merit industries, inc.

FIELD BULLETIN

Date: 6-29-06

FIGURE 1 – CORRECT WIRING OF MOD BOX COIN MECH

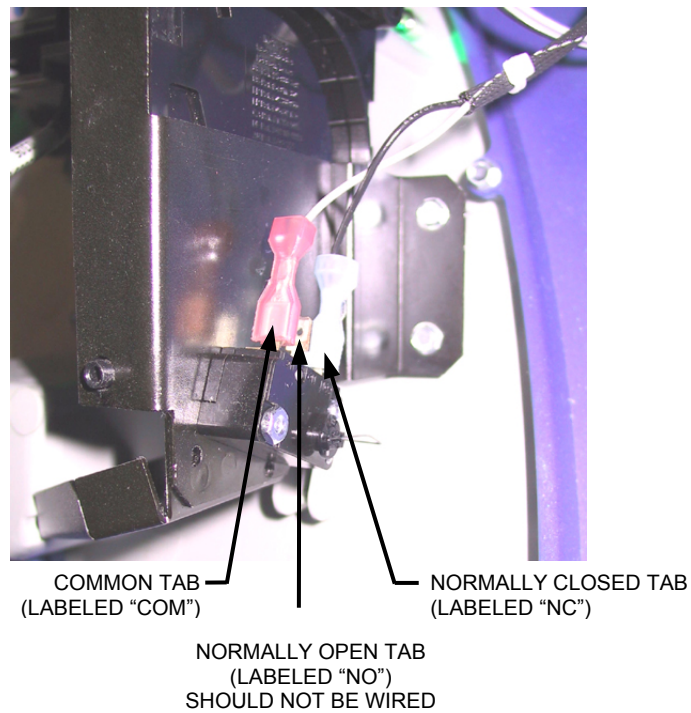
- Issue:** Some MoD BoX jukeboxes were built with the coin switch wired incorrectly.
- Games affected:** MoD BoX jukeboxes built prior to June 23, 2006. The first six digits of the serial number represent the date the game was built.
- Symptoms:** If the coin mech is wired incorrectly, the coins may not always register.
- Solution:** Unlock and open the MoD BoX door and check the wiring of the coin mech mounted on the door. The wires should be connected to the outside terminals on the coin switch (the common and normally closed tabs) as shown in the picture below. If the coin mech wiring is incorrect, turn off the jukebox and move the fast-on connector from the normally open tab to the normally closed tab as shown below.
